**HarborView Block**  
 Portland, Maine

RE: HarborView Block  
Traffic and Parking Review

**RE: Harbor View Block Site Plan Review**

**RE:** 145 Commercial Street  
(city block bounded by Commercial, Fore, Market & Silver Streets)

# OFF-SITE LOADING PLAN

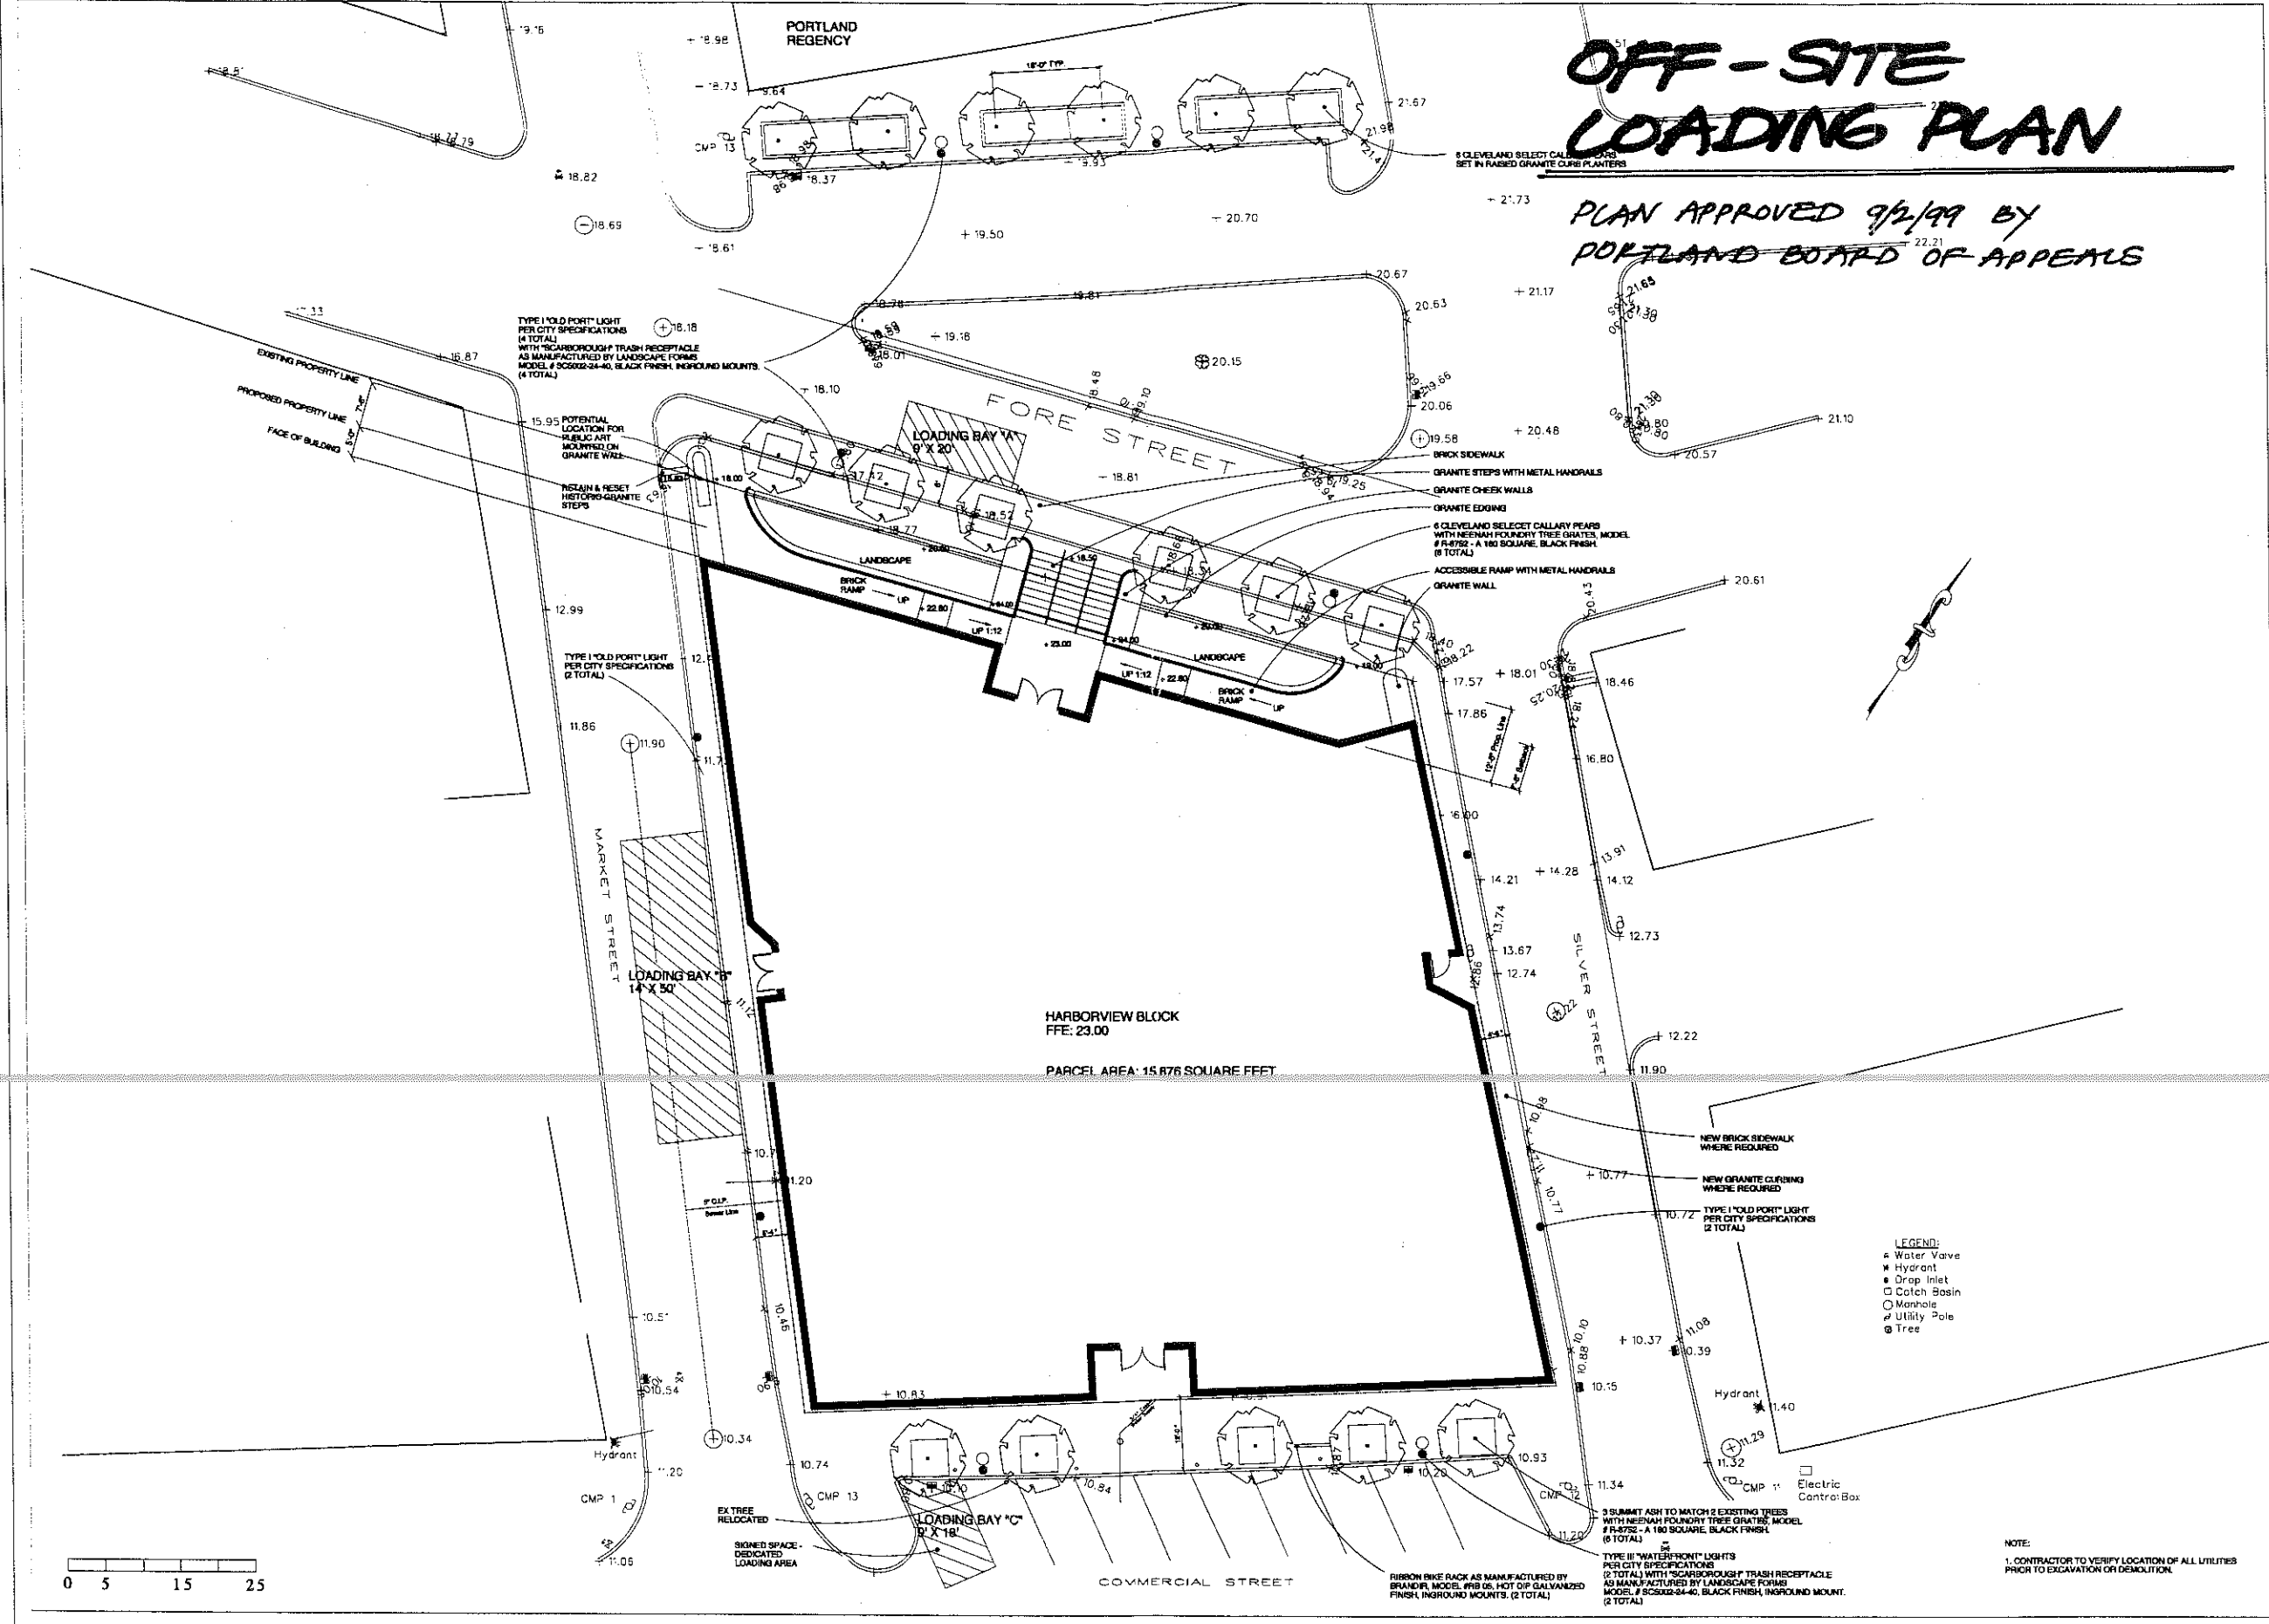
145 Commercial Street, Mr. Eric Cianchette/E.L.C., Inc., owner of the property. The Board voted 5-0 to allow for relief from requiring off-street loading bays, which will be provided in several locations, with the condition that the use of the loading zone on Market St. shall not unnecessarily interfere with the existing loading zone, including but not limited to, the loading zone servicing the building at 161 Commercial St., B-3 Zone.

Site Plan  
 1/16" = 1'-0"  
 9/8/99

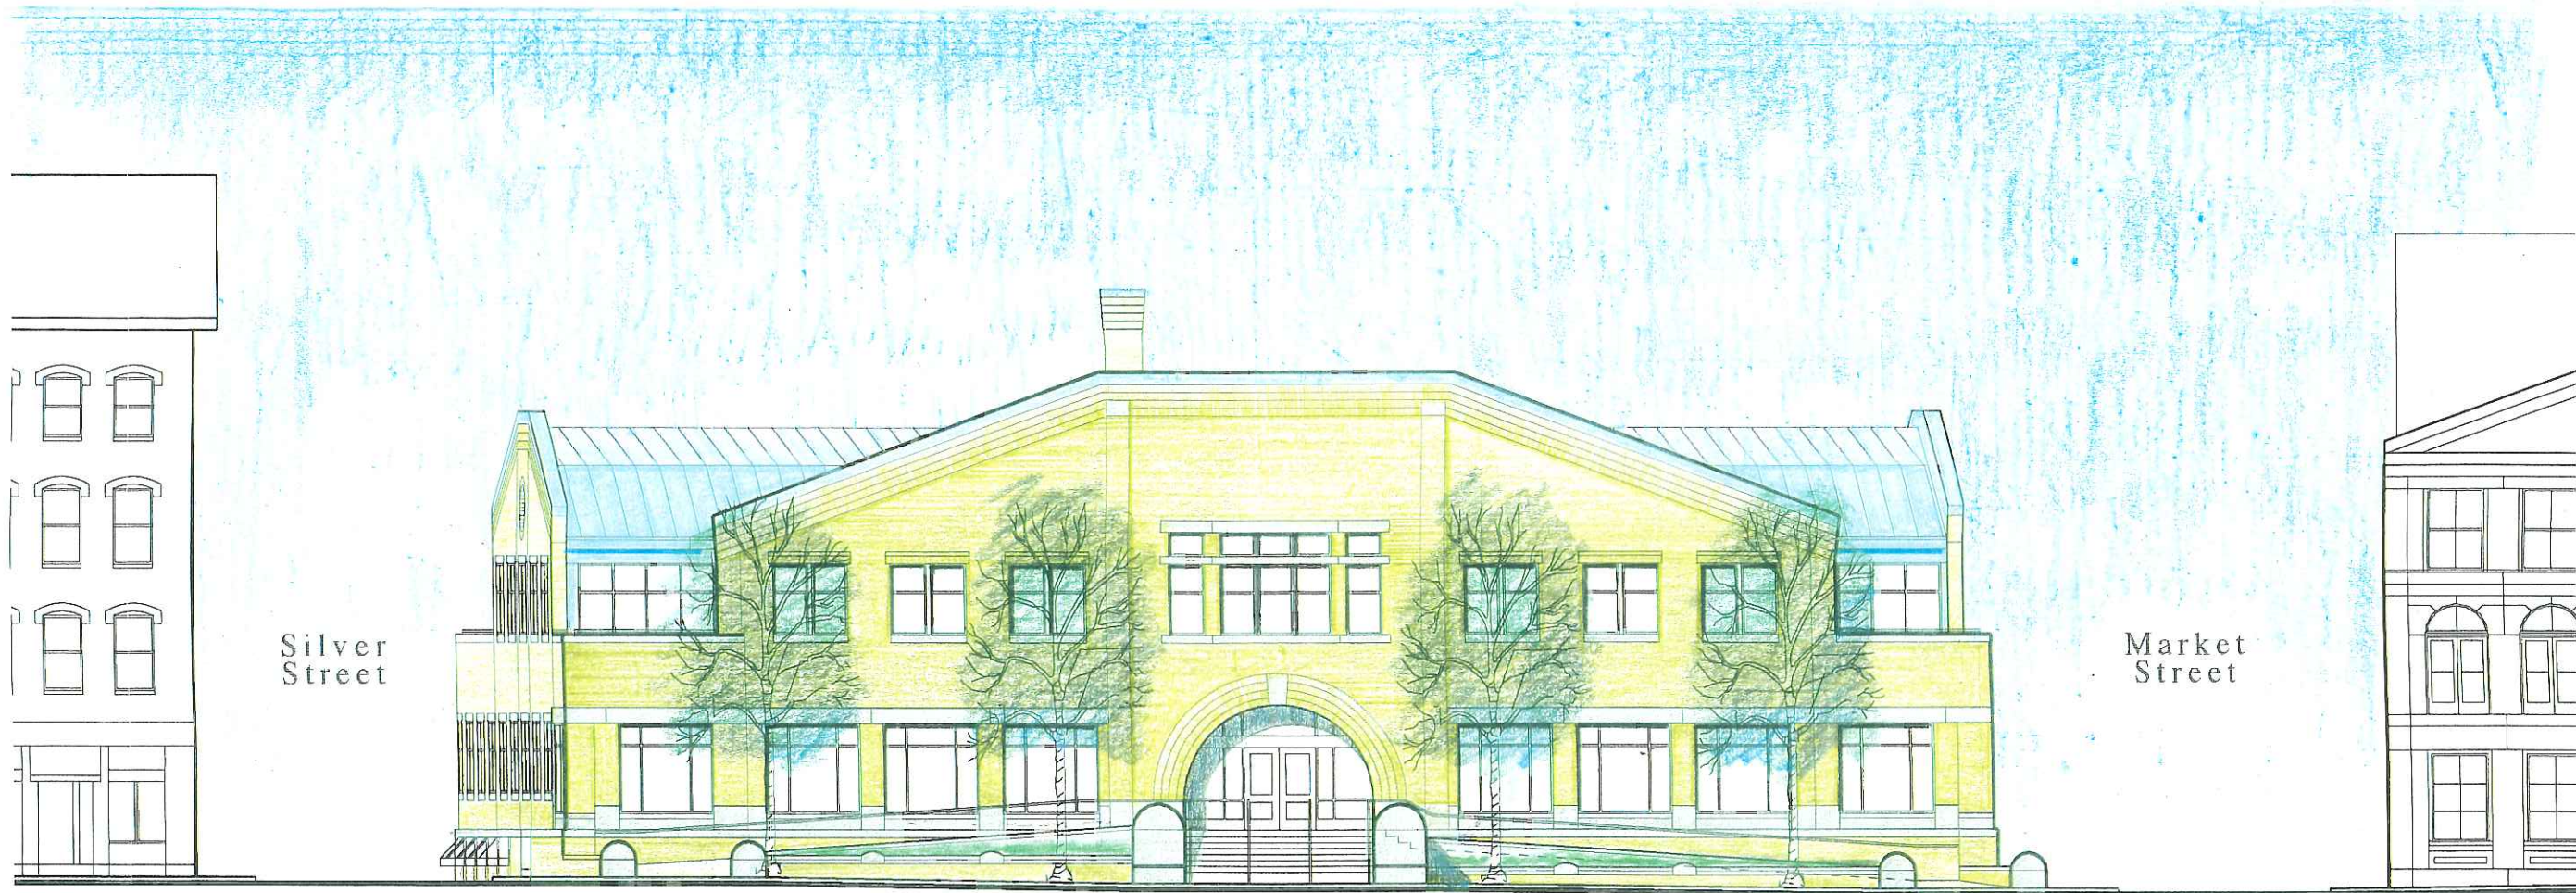
Enclosed are several documents that reflect refinements made to the Fore Street side of the proposed Harborview Block. The design refinements are summarized below:

1. Hold the Street Edge

There is a desire to establish the street edge, along Fore Street, with a strong design of streetscape elements. The edge of the Harborview Block facing Boothby Square is reinforced with both the edges of a granite capped seat wall and six raised end caps. As one approaches Harborview Block along Fore Street these end caps form a strong edge fronting on the street. The geometry of Fore Street is reinforced by this solid seat wall edge. The building façade sits back from this edge, following the same geometry.
